FOR USE WITH THE 4TH EDITION CPCS LAST REVISED APRIL 1, 2024

SUPPLEMENTARY CONDITIONS – CONTRACT ******

SCOPE. These Supplementary Conditions amend or supplement the General Conditions and other provisions of the Contract Documents. All provisions not so amended or modified remain in full force and effect.

22010 WASHDOWN PIPING SCHEMATIC

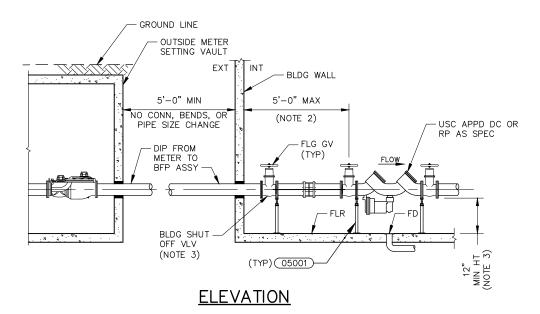
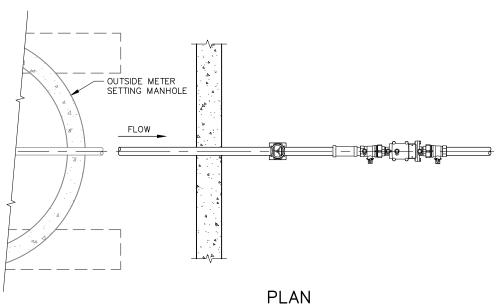
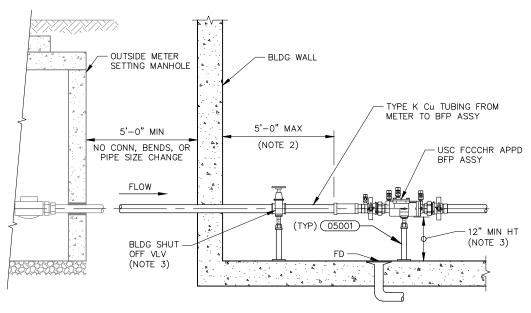
Engineer: If DETAIL 22010 is applicable to your project, the following change MUST stay in the Supplementary Standard Details

DETAIL 22010 – WASHDOWN PIPING SCHEMATIC

DETAIL 22010 (In its entirety)

DETAIL 22010 (located in the Standard Details Appendix)

DRAWN BY: BAIRES	22015
CHKD BY: K ROSS/ KAR	INSIDE BACKFLOW PREVENTION
APPD BY:] ASSEMBLY FOR OUTSIDE SETTING
ORIGINATION DATE: JULY 2021	OF 1 1/2" & 2" METER & BYPASS
REVISION DATE: NOVEMBER 2022	N A MANHOLE

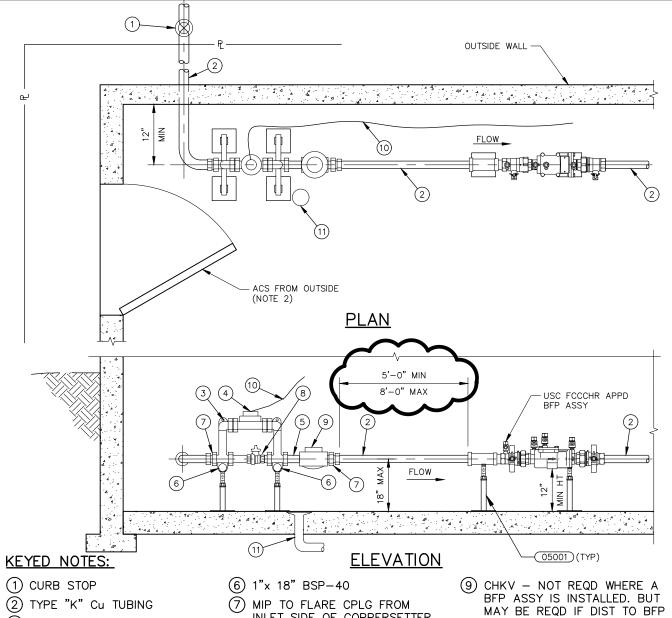
Engineer: If DETAIL 22015 is applicable to your project, the following change MUST stay in the Supplementary Standard Details

DETAIL 22015 – INSIDE BACKFLOW PREVENTION ASSEMBLY FOR OUTSIDE SETTING OF 1 1/2" & 2" METER & BYPASS IN A MANHOLE

DETAIL 22015 (In its entirety)

DETAIL 22015 (located in the Standard Details Appendix)

DRAWN BY: BAIRES *22016* CHKD BY: K ROSS/ KAR INSIDE SETTING FOR 1 1/2" & 2" METER & BYPASS W/ INSIDE ORIGINATION DATE: JULY 2021 BACKFLOW PREVENTION ASSY REVISION DATE: NOVEMBER 2022

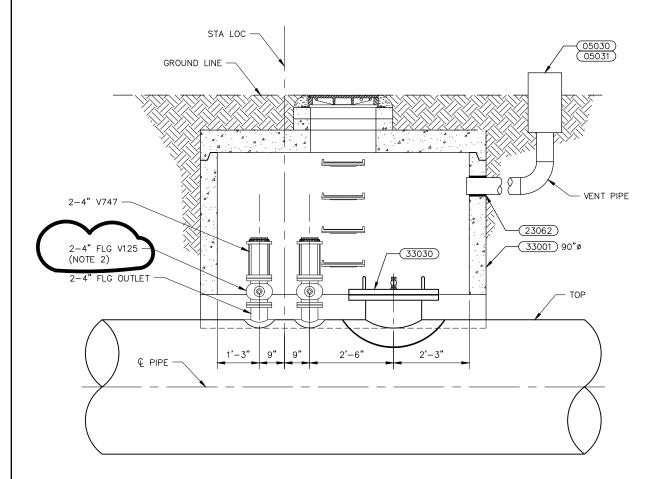
Engineer: If DETAIL 22016 is applicable to your project, the following change MUST stay in the Supplementary Standard Details

DETAIL 22016 – INSIDE SETTING FOR 1 1/2" & 2" METER & BYPASS W/ INSIDE BACKFLOW PREVENTION ASSY

DETAIL 22016 (In its entirety)

DETAIL 22016 (located in the Standard Details Appendix)

33006 4" AIR VALVE ASSEMBLY WITH 20" ACCESS MANHOLE (STEEL PIPE)

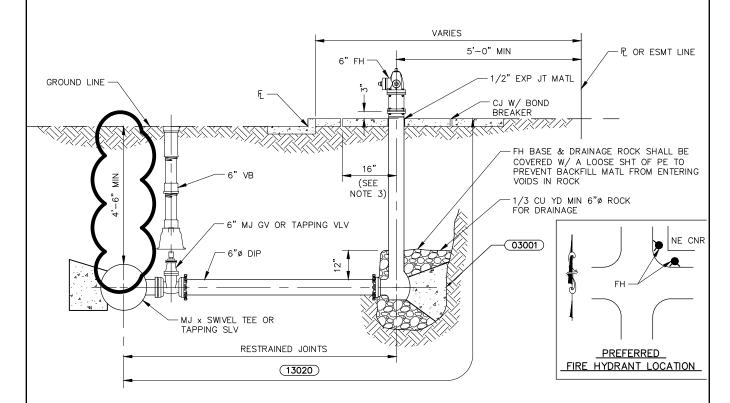
Engineer: If DETAIL 33006 is applicable to your project, the following change MUST stay in the Supplementary Standard Details

DETAIL 33006 - 4" AIR VALVE ASSEMBLY WITH 20" ACCESS MANHOLE (STEEL PIPE)

DETAIL 33006 (In its entirety)

DETAIL 33006 (located in the Standard Details Appendix)

33263 NATIONAL FIRE PROTECTION ASSOCIATION 13D RESIDENTIAL SPRINKLER SERVICES

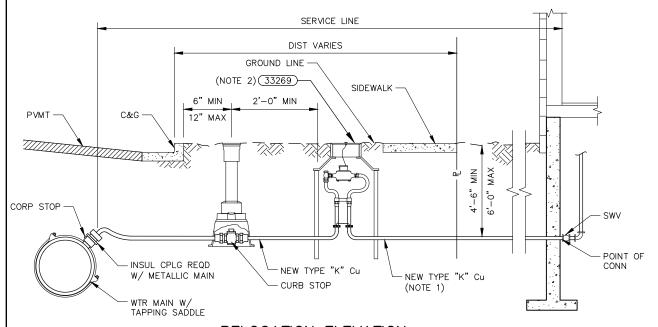
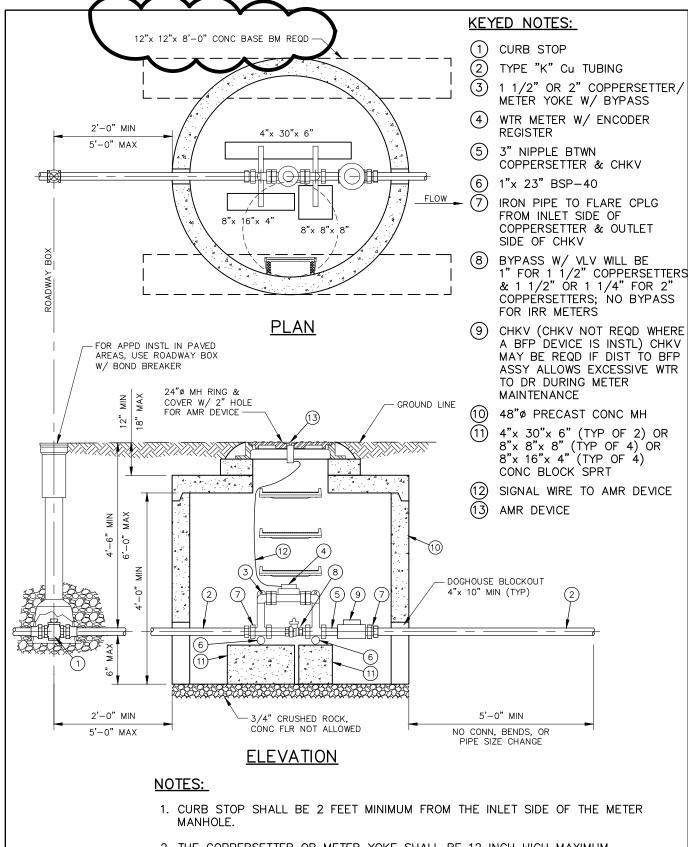
Engineer: If DETAIL 33263 is applicable to your project, the following change MUST stay in the Supplementary Standard Details

DETAIL 33263 –NATIONAL FIRE PROTECTION ASSOCATION 13D RESIDETIAL SPRINKER SERVICE

DETAIL 33263 (In its entirety)

DETAIL 33263 (located in the Standard Details Appendix)

OUTSIDE SETTING FOR 2" & SMALLER DOUBLE CHECK VALVE ASSEMBLY IN MANHOLE

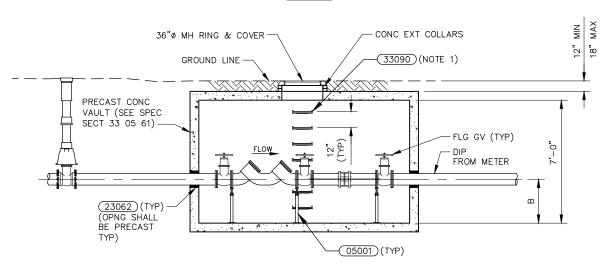
Engineer: If DETAIL 33280 is applicable to your project, the following change MUST stay in the Supplementary Standard Details

DETAIL 33280 - OUTSIDE SETTING FOR 2" & SMALLER DOUBLE CHECK VALVE ASSEMBLY IN MANHOLE

DETAIL 33280 (In its entirety)

DETAIL 33280 (located in the Standard Details Appendix)

DRAWN BY: BAIRES] <i>33281</i>
CHKD BY: K ROSS/ KAR	OUTSIDE SETTING FOR 2 1/2"
APPD BY:	
ORIGINATION DATE JULY 2021	TO 10" DOUBLE CHECK
REVISION DATE: AUGUST 2022	VALVE ASSEMBLY IN VAULT

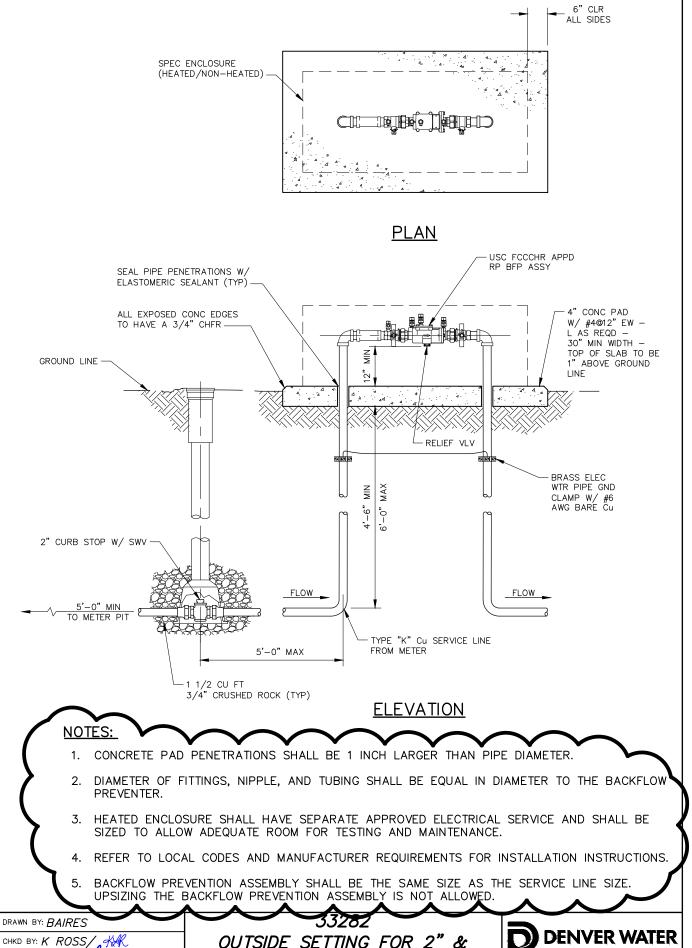
Engineer: If DETAIL 33281 is applicable to your project, the following change MUST stay in the Supplementary Standard Details

DETAIL 33281 – OUTSIDE SETTING FOR 2 1/2" TO 10" DOUBLE CHECK VALVE ASSEMBLY IN VAULT

DETAIL 33281 (In its entirety)

DETAIL 33281 (located in the Standard Details Appendix)
